**Zoning Public Hearing
CITY OF AUSTIN
RECOMMENDATION FOR COUNCIL ACTION**

SUBJECT: C814-90-0003.13 - Harris Branch PUD Amendment #13 - Conduct a public hearing and approve an ordinance amending Chapter 25-2 of the Austin City Code by rezoning property located at 1375 U.S. Highway 290 East at Proposed State Highway 130 (Harris Branch, Gilleland Creek, Decker Creek Watersheds) from planned unit development (PUD) district zoning to planned unit development (PUD) district zoning to change a condition of zoning. Zoning and Platting Commission Recommendation: To grant planned unit development (PUD) zoning with conditions. Applicant: Austin HB Residential Properties (John McCullough). Agent: Minter, Joseph & Thornhill, P.C. (John M. Joseph). City Staff: Sherri Sirwaitis, 974-3057.

ZONING CHANGE REVIEW SHEET

CASE: C814-90-0003.13

Current Approved Harris Branch PUD Land Use Plan

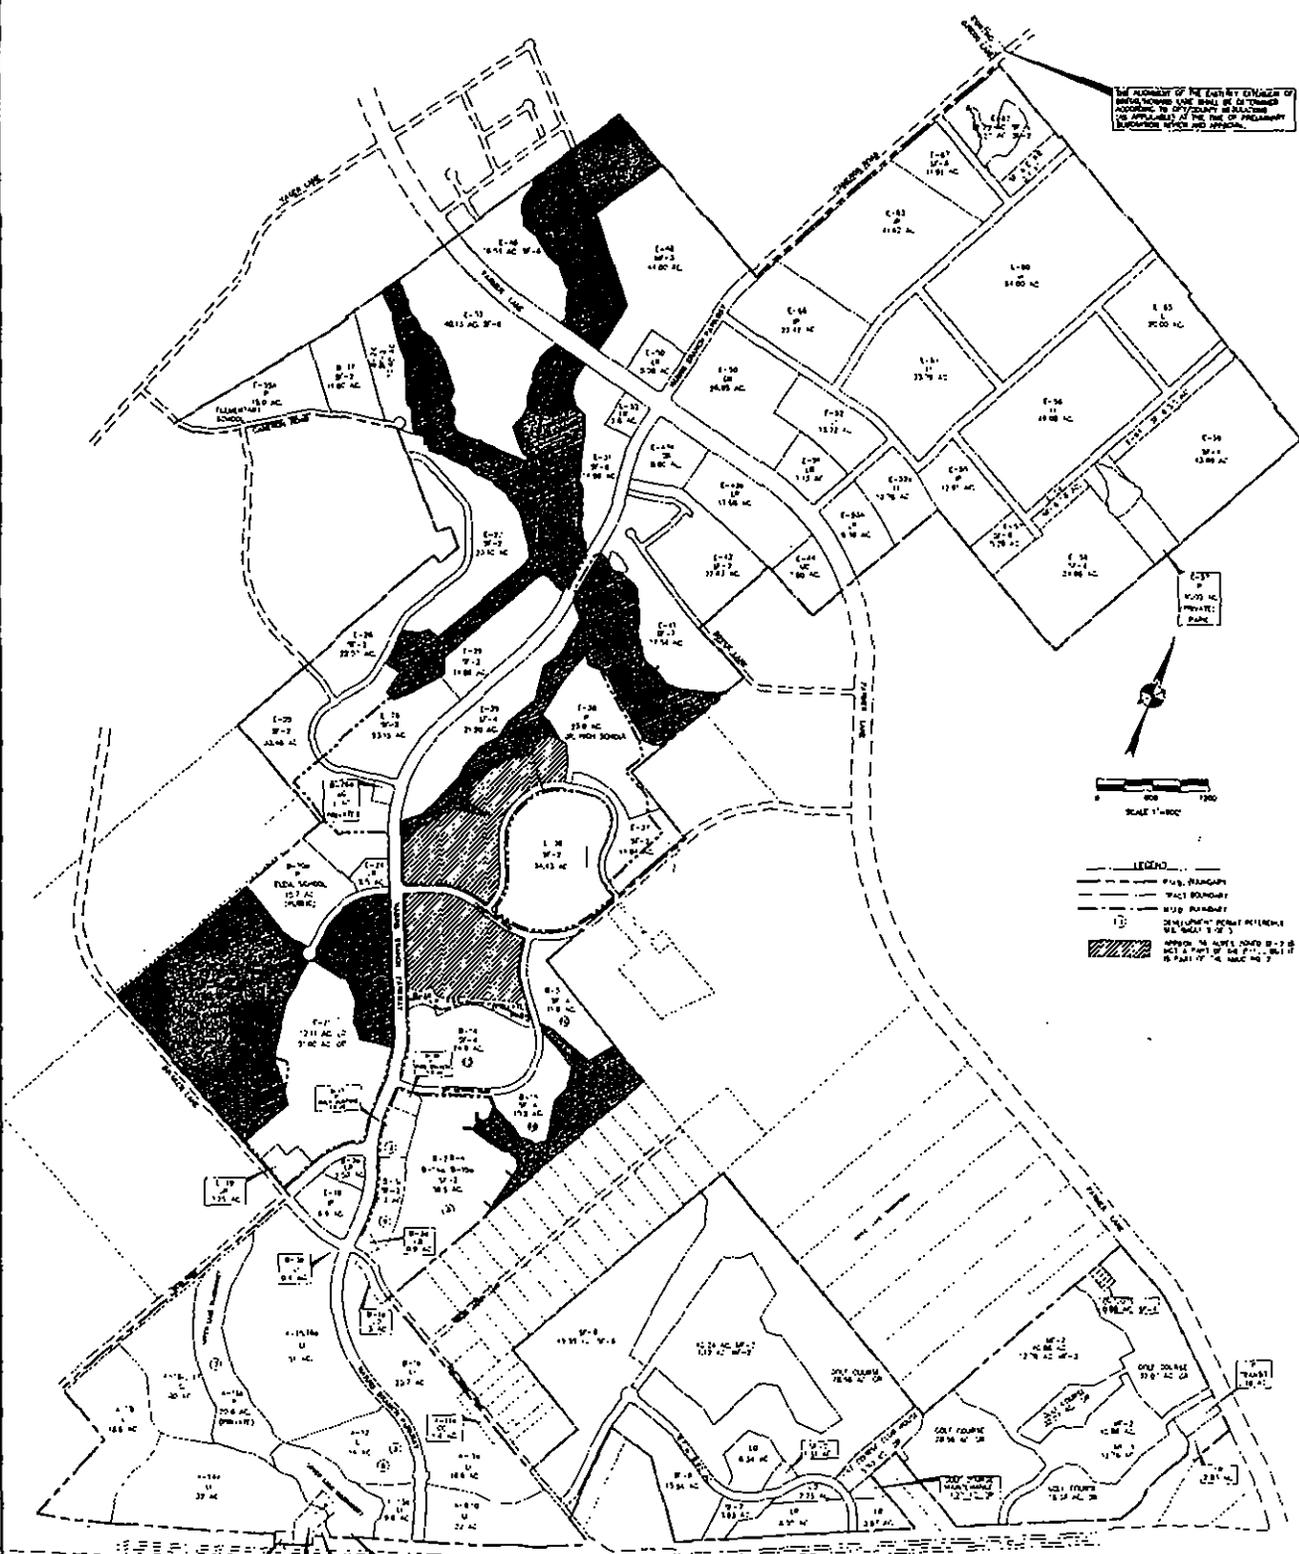
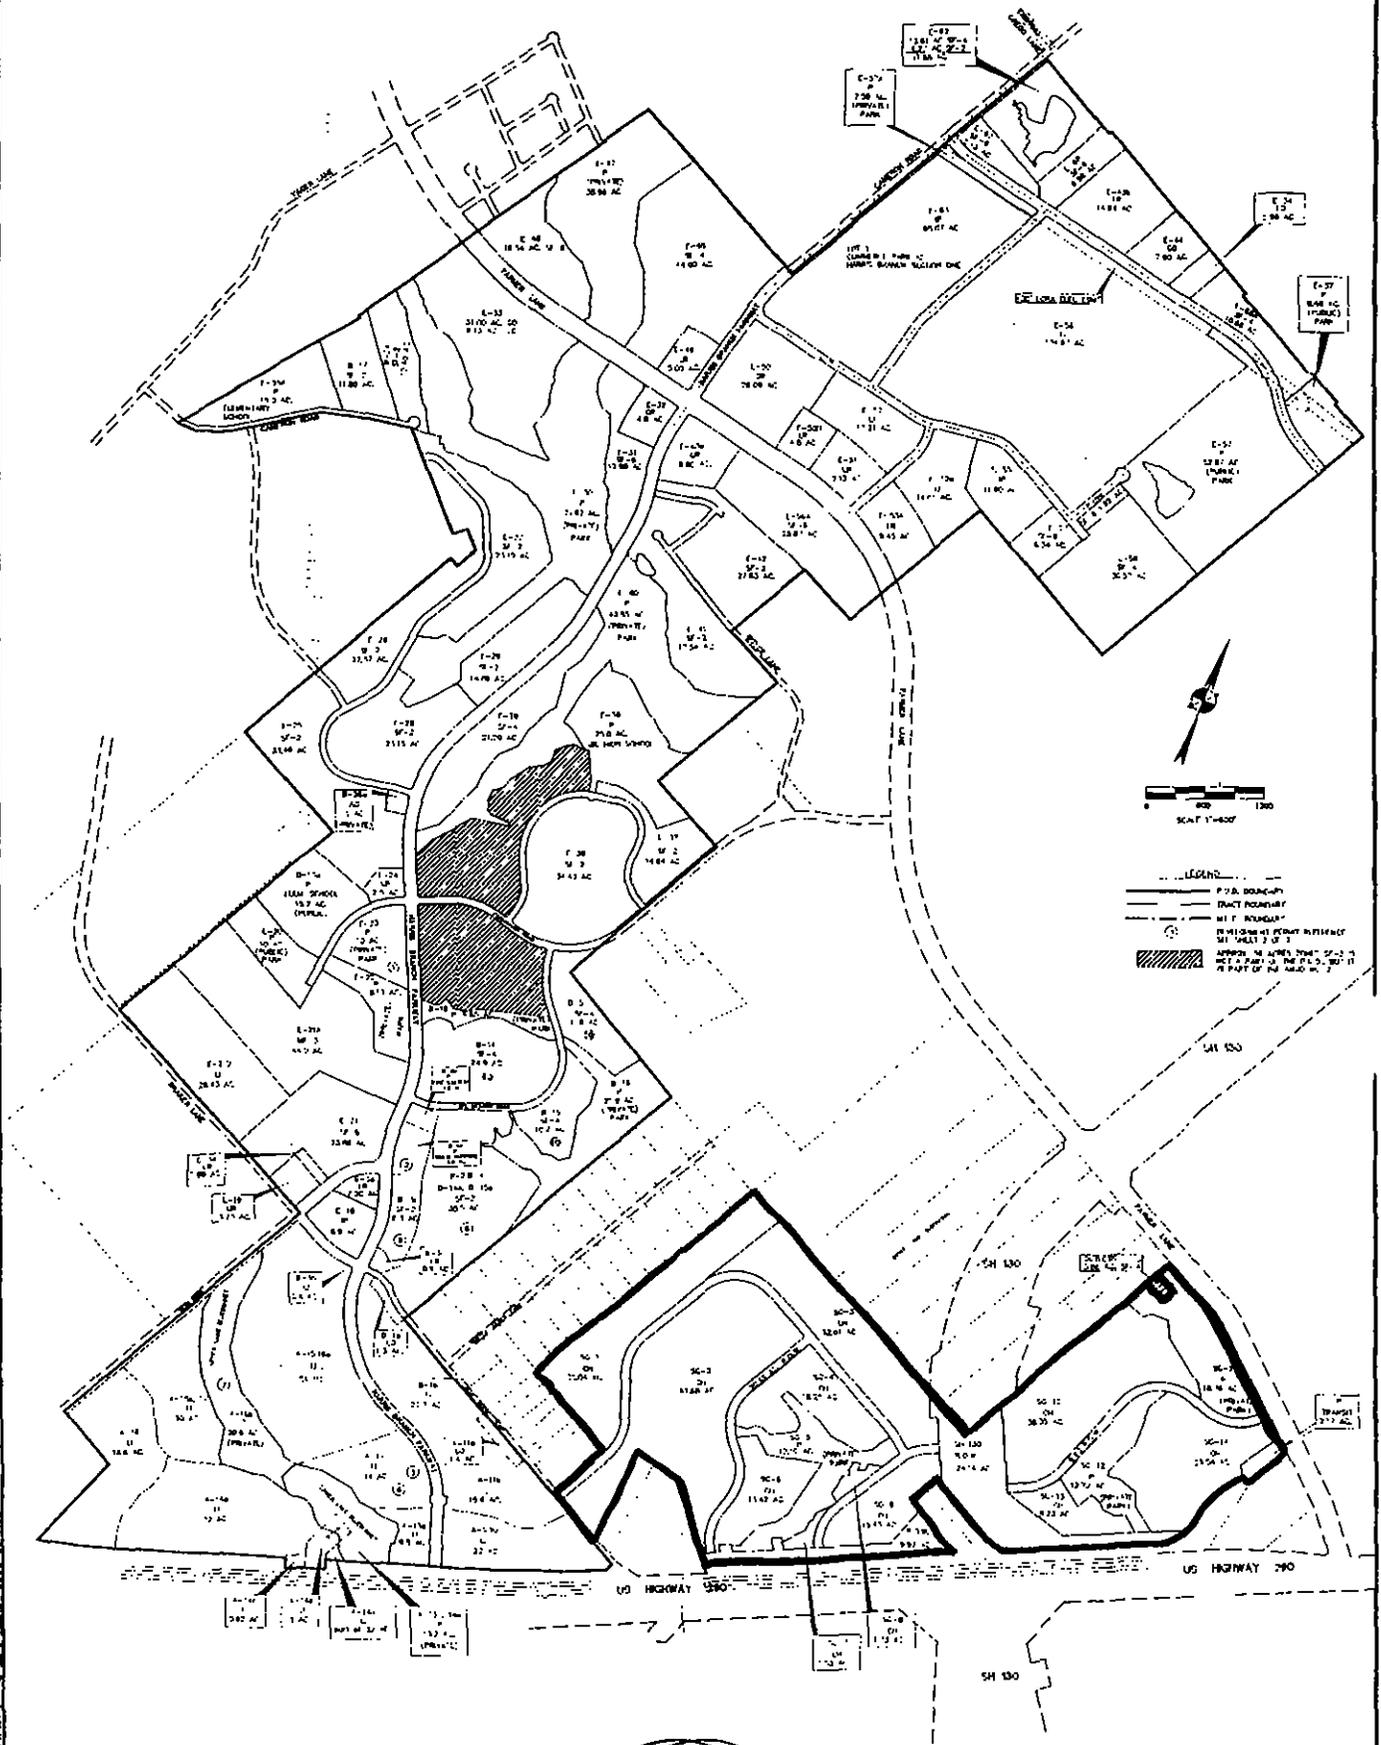
It is difficult to tell on sheet 2 of the PUD plan what has changed, since Revision 13 is with 11 & 12, and the changes were not clouded.

Please redline the approved Harris Branch PUD Land Use Plan to directly show the proposed changes for the PUD. Please redline the PUD Densities Tables - Sheet 2 to display how the proposed revisions to Tracts SG-1 through SG-14 will affect the breakdown of uses and within the PUD. Please provide information concerning the how the proposed land use changes will affect the overall building coverage and impervious cover amounts within the PUD.

ZN-2 The Harris Branch PUD Land Use Plan has a “red line” drawn around the areas subject to this amendment. Attached Please see the revised Harris Branch Density Tables -- Sheet 2 showing the effect on building coverage and impervious cover.
